Technical Review

PROJECT: Regents Wharf - 10-18 All Saints St.

Review of GIA Light Pollution Report

PROJECT NUMBER: 1448		DOCUMENT REF: 1448-DFL-TR-001			
A	For Issue	AS	RC	RC	11/03//2020
Revision	Purpose Description	Originated	Checked	Approved	Date

Figure 2 Fig 01 Area Map from GIA report

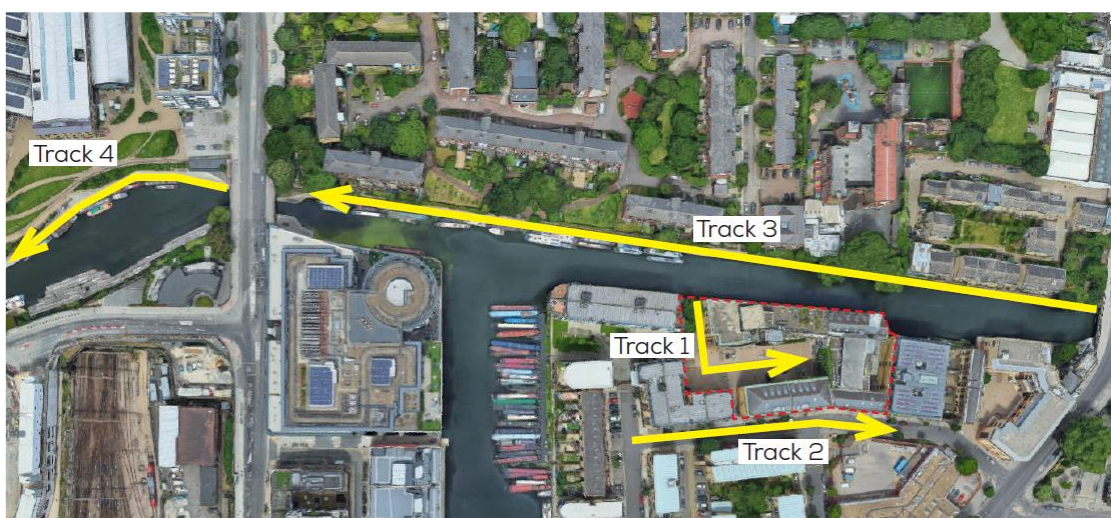
- 2.2.1 The GIA report details the baseline measurements on Tracks 1 to 4 (See Fig 1 below), this information will be reviewed and the impact upon specific sensitive receptors assessed.

- 2.3.2 The section of Track 1 which runs South from the canal between Ice Wharf and Regents Wharf is very dark. Further along the track, there is a security light which is on all night, The new building (Thorley House) will run from the canal to the street, there won't be the courtyard that is there now; the new building will be closer to Ice Wharf than it is now when it infills the courtyard, and much taller than the existing buildings; the windows will be much larger and much closer so it's even more important that they have blinds etc

- 2.3.3 During the Light Impact Assessment, the baseline survey should have measured the baseline vertical illuminance levels at the windows of the sensitive receptors in the Ice Wharf development and compare the baseline light levels to cumulative post-development light levels. Following this methodology, the impact of artificial light from the Proposed Development can be appropriately assessed

- 2.3.4 The measured light levels have no meaning and relevance and do not comply with any guidance on undertaking light impact assessments. No reference has been made to the Institution of Lighting Professionals guidance PLG04 "Guidance on Undertaking Light Impact Assessments".

- 2.4.1 The GIA report states that the main source of light along this track is provided by the street lighting. The street lighting here is a modern LED unit which is full cut-off to reduce light spill and therefore is unlikely to provide much vertical illuminance on the windows of 1-3 All Saints Street. The street is very typical of an E3 Environmental Zone, there is little night-time activity. We would expect to see evidence showing that there is little impact on the apartment windows with the additional light from the Proposed Development. This would require a proper baseline assessment following the methodology discussed above.

- 2.5.1 There are a number of sensitive receptors adjacent to the towpath. As detailed above, the assessment should detail vertical illuminance on bedroom windows as detailed in the ILP guidance. In particular, the sensitive receptors in Treaty Street and Thornhill Bridge Wharf should be assessed and a cumulative impact detailed which includes the baseline and both interior and exterior lighting proposed as part of the Proposed Development.
